**Subject:** San Mateo Park Elementary School HVAC Replacement  
San Mateo - Foster City School District  
Aedis Project No. 2021011.08  
DSA Application #01-120214

### ADDENDUM NO. 1

San Mateo Park Elementary School HVAC Replacement  
San Mateo – Foster City School District  
Aedis Project No. 2021011.08

DATE **11/28/2022**  
JOB # **2021011.08**  
SHEET # **AD1-  
A2.01**

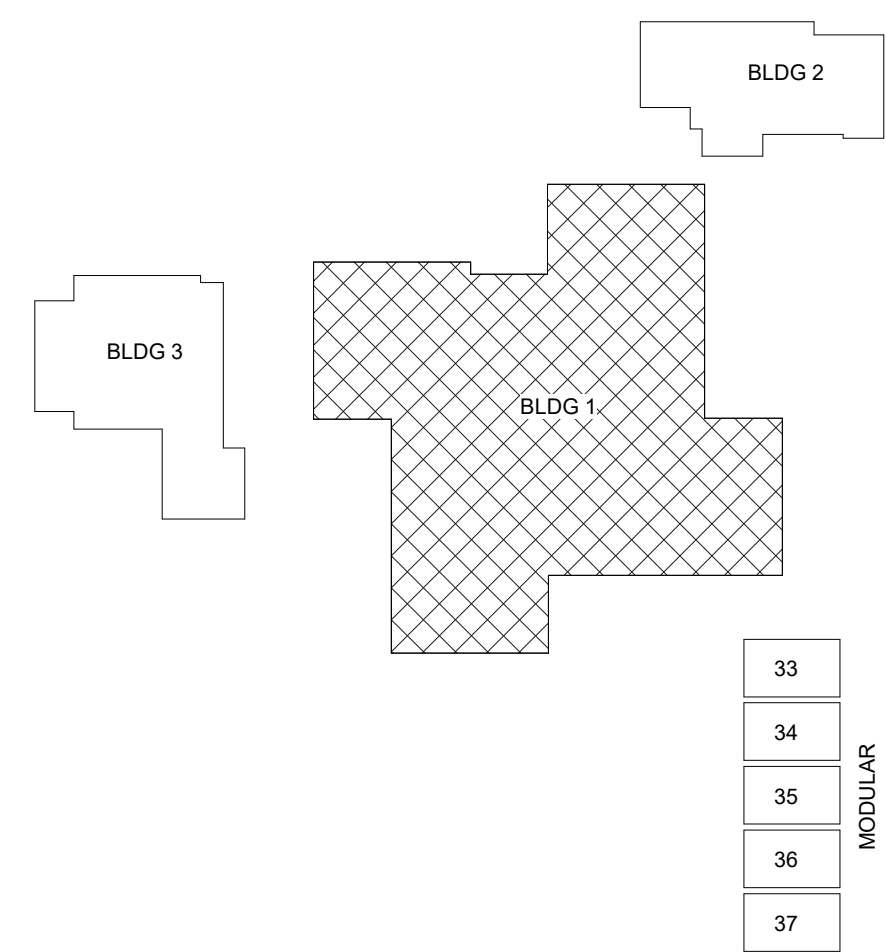
Add: Floor Plan Keynote 23.108 as shown per AD1-A2.01

Revise: Keynote tag at Library for rooftop unit as shown per AD1-A2.01

1 REFLECTED CEILING PLAN - BLDG 1  
SCALE: 1/8" = 1'-0"

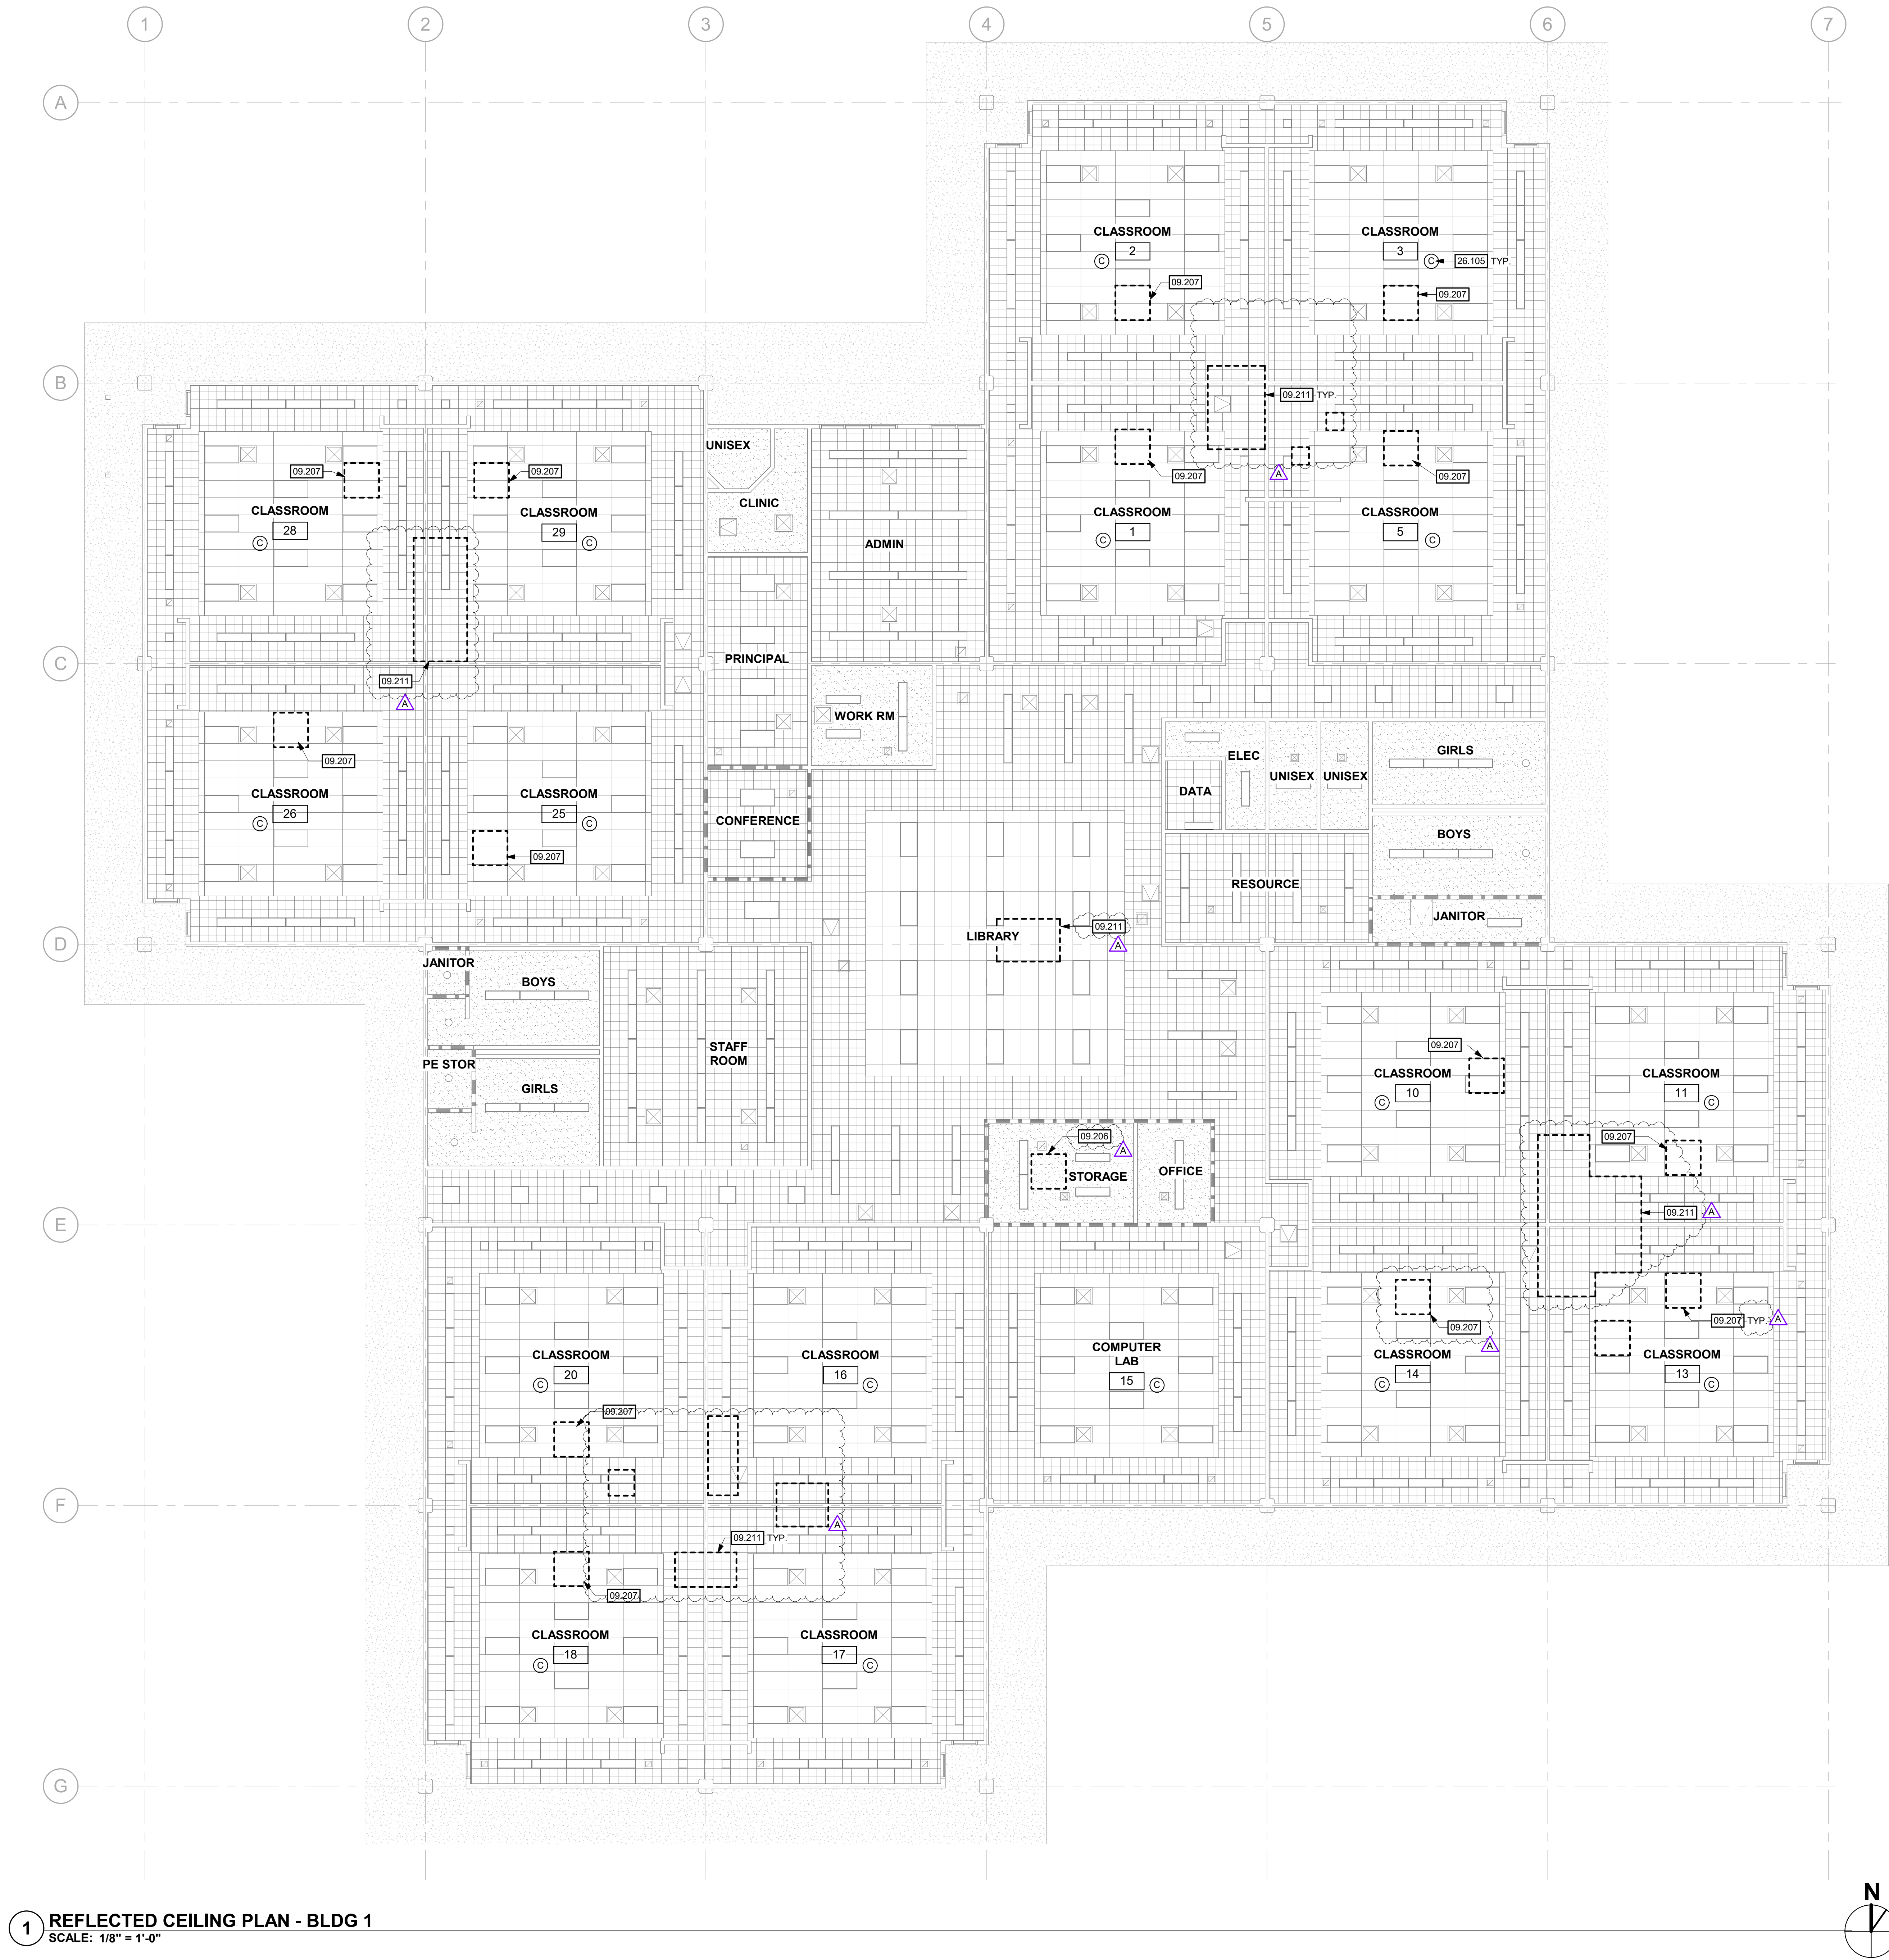
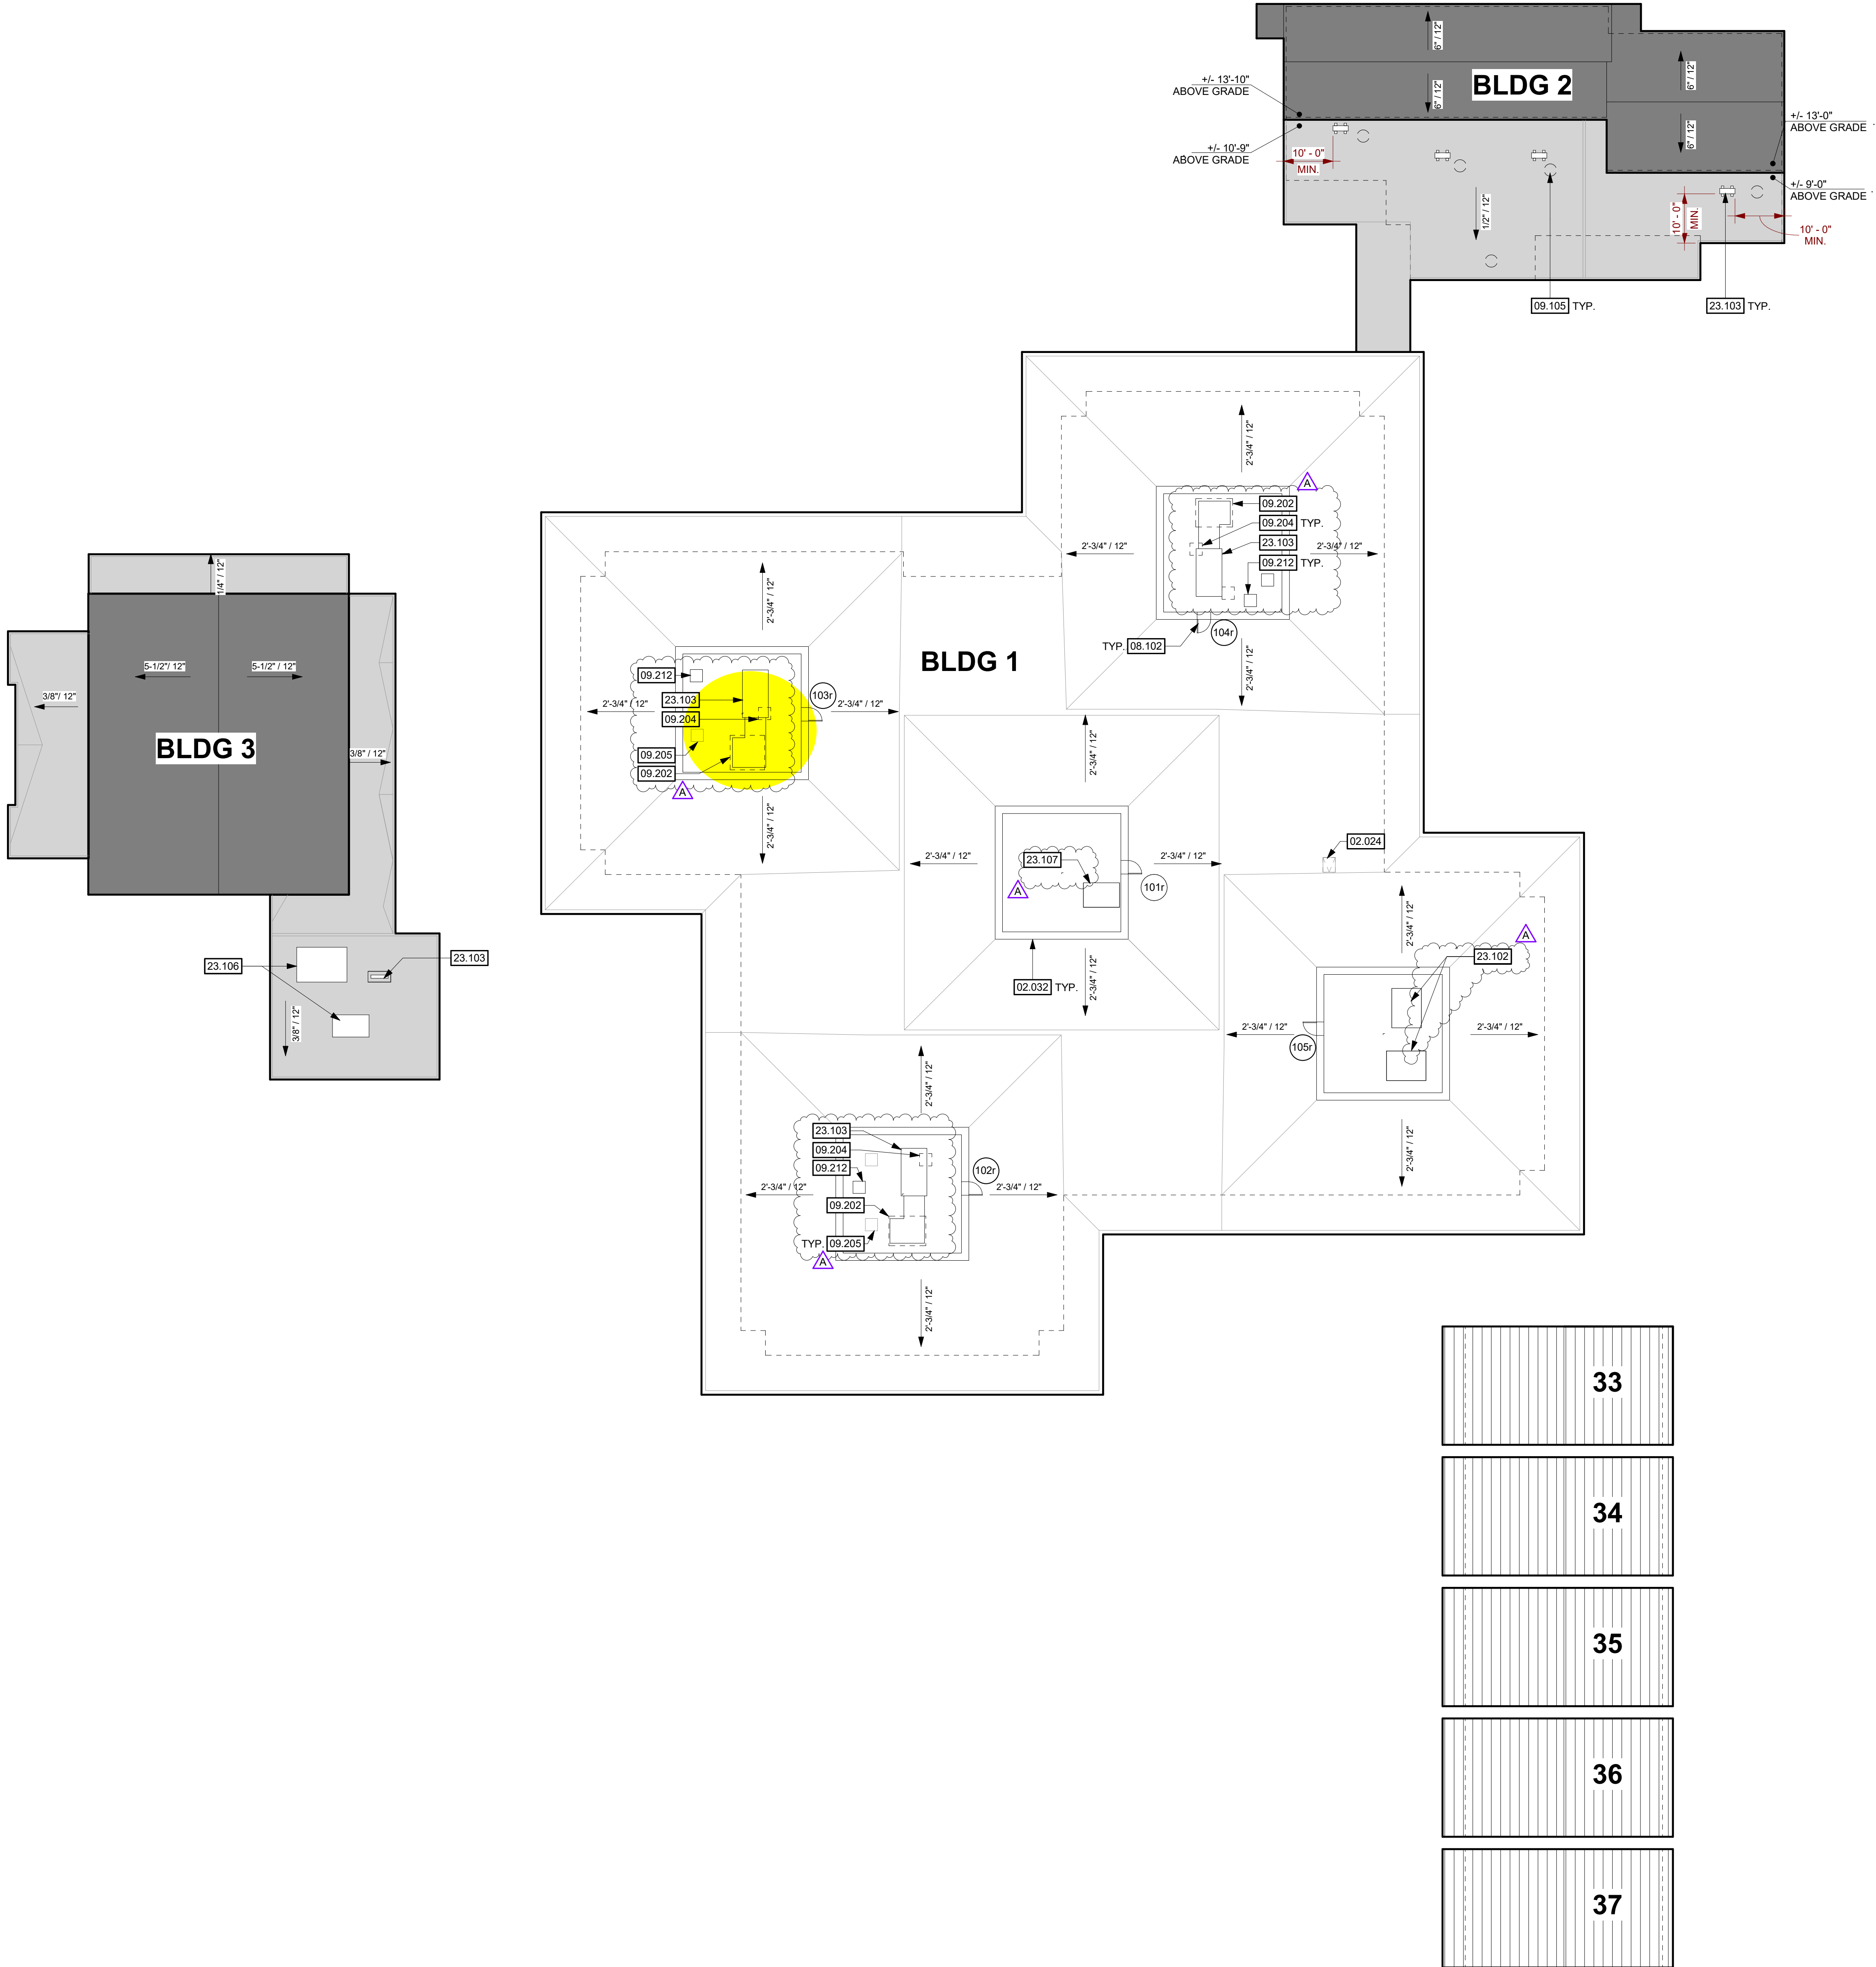
Remove: Keynotes 09.203 and 23.105

Add: Reflected Ceiling Plan Keynotes 09.206 & 09.211 and associated tags in plan as shown per AD1-A4.01

Revise: Keynote tags for 09.207 as shown per AD1-A4.01
